BAR 15-04-06
500 Court Square
Tax Parcel 530096000
Thomas Michie, TR -1st Mont LD TR, Owner/ USCOC of Virginia RSA#3, Inc, Applicant
Replace 6 antennas and add one new cabinet on roof

**CITY OF CHARLOTTESVILLE
BOARD OF ARCHITECTURAL REVIEW
STAFF REPORT
April 21, 2015**

Project Report for LTE Upgrade Project

Photo Simulations

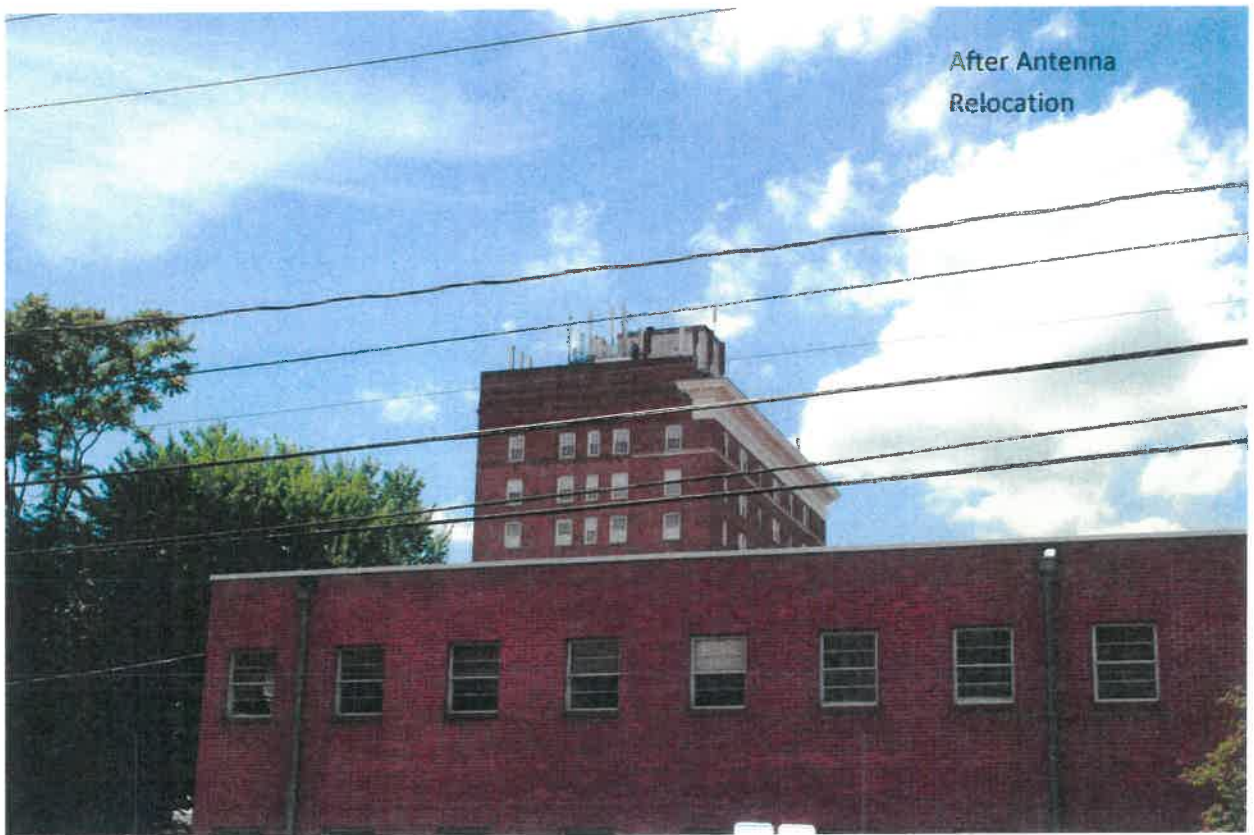
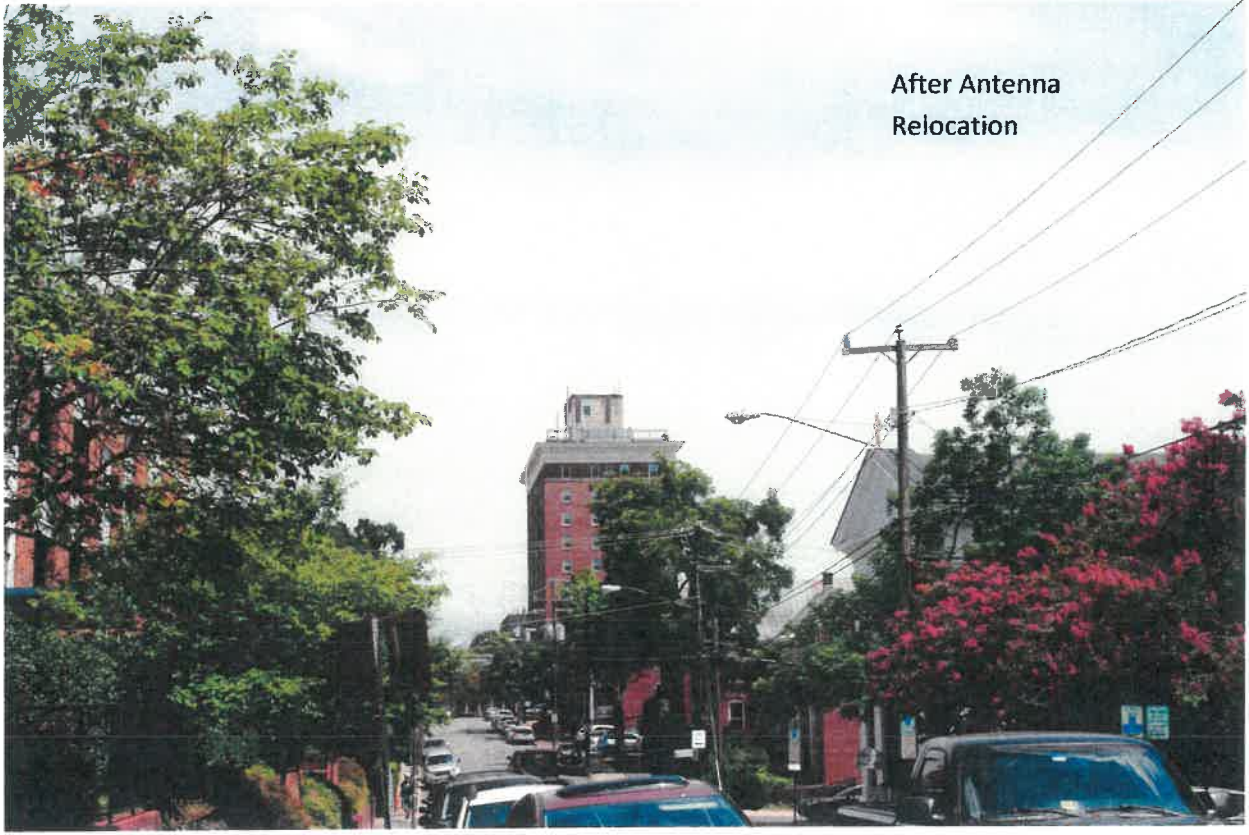
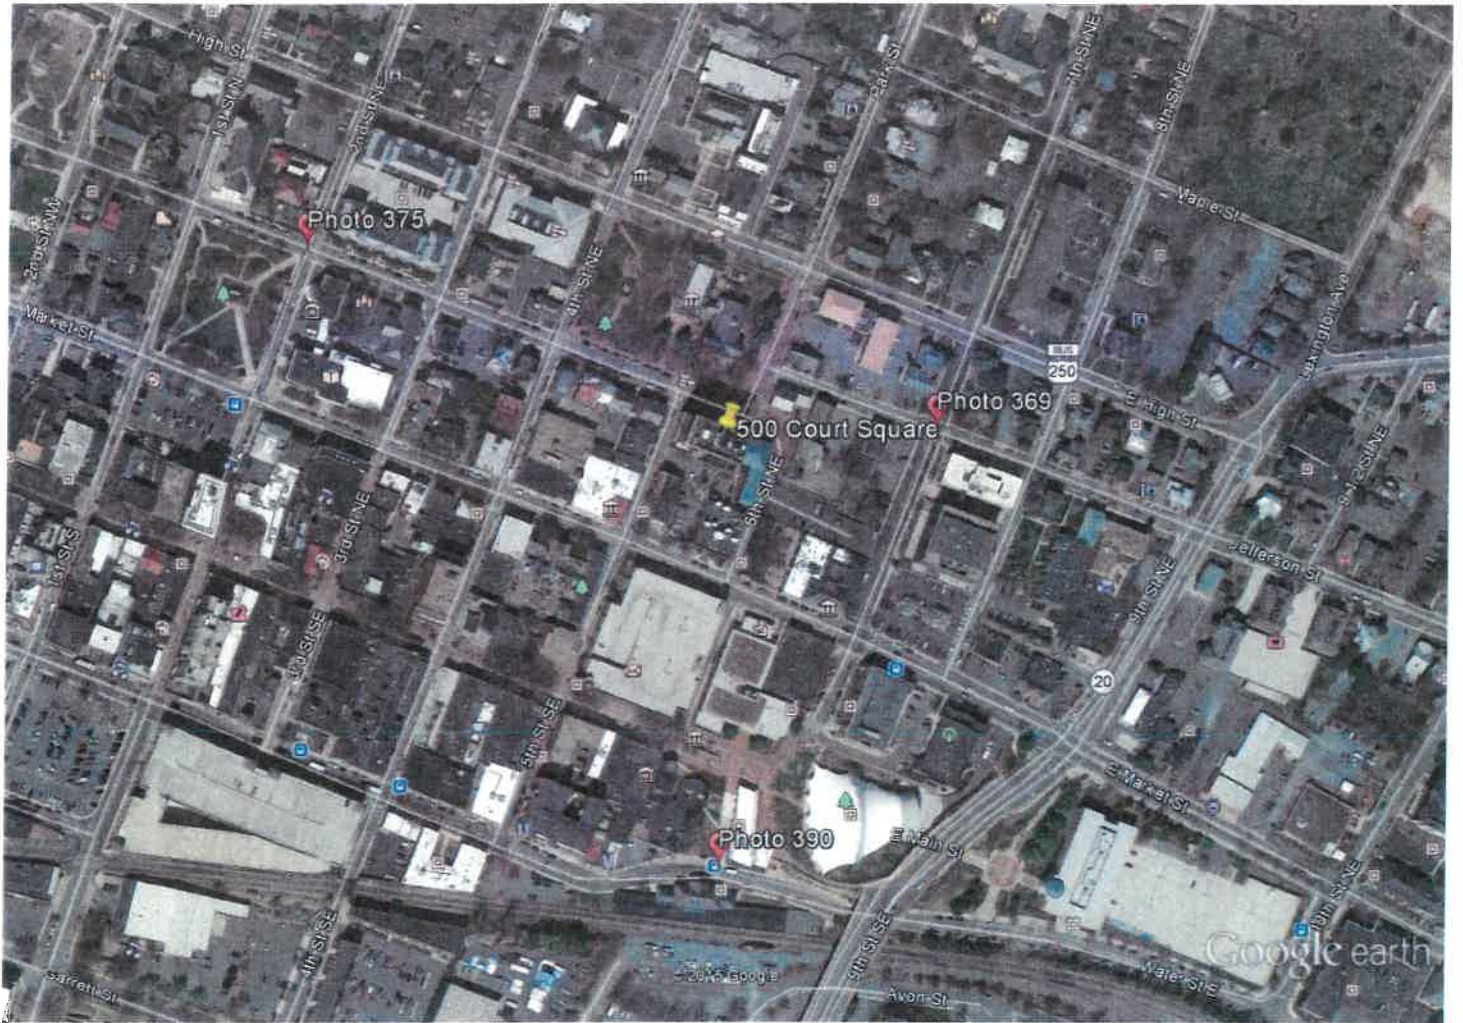
Because the antennas are existing and not screened, they are considered non-conforming. This proposal will make them less non-conforming. Staff commends the property owner and the utility for working together to improve the City's most important historic district.

- USCC is proposing to replace six (6) of its existing antennas which are currently mounted on the side of the elevator penthouse. The mounts are located so that all six (6) of the antennas protrude up above the elevator penthouse roofline. While the antennas are 101"x10"x4" which is quite small in terms of the overall mass of the building and the elevator penthouse they are mounted in a manner that "skylines" them from most views of the building. This creates a very negative aesthetic and causes a seemingly small feature to become a very dominate part of the building. The proposed project will cause the removal of all six (6) of these antennas and allow USCC to move the mounting system down on the elevator penthouse walls so that when the replacement antennas are installed, they will remain below the elevator penthouse roof. This will eliminate the "skyline" effect and thereby reduce a majority of negative aesthetics that these antennas bring to the rooftop. As an additional mitigation step, USCC will paint the antennas and mounts the same color as the elevator penthouse façade. This will help the antennas further blend into the walls and possibly eliminate their effect on the view of the building from further views or to a casual observer.

- This modification is proposed as a temporary installation to help slowly bring the entire USCC facility down to the roof deck and eventually behind screening panels. This first step will help bring the USCC facility closer to an acceptable design for this district by improving on its affect through the use of a revised height placement and color (currently the antennas are white). These two features ultimately help to reduce the perceived mass of the antennas by making them a less dominate feature.

The BAR approved (8-0) the application as submitted.
